RE: Application 19-6538 – 3960 Third Avenue, Willis Selden HD

Request to modify work approved in COA issued December 18, 2019. The modifications will retain more of the existing/historic appearance than what was originally approved. Please see the attached revised drawings.

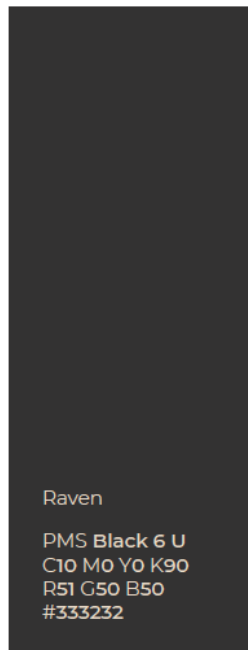
Fill in this door to match existing wall surface

Retain opening- install metal overhead door, wall surface and pedestrian door – both to be sided to match metal overhead door and read as one large overhead door

Repair to match existing
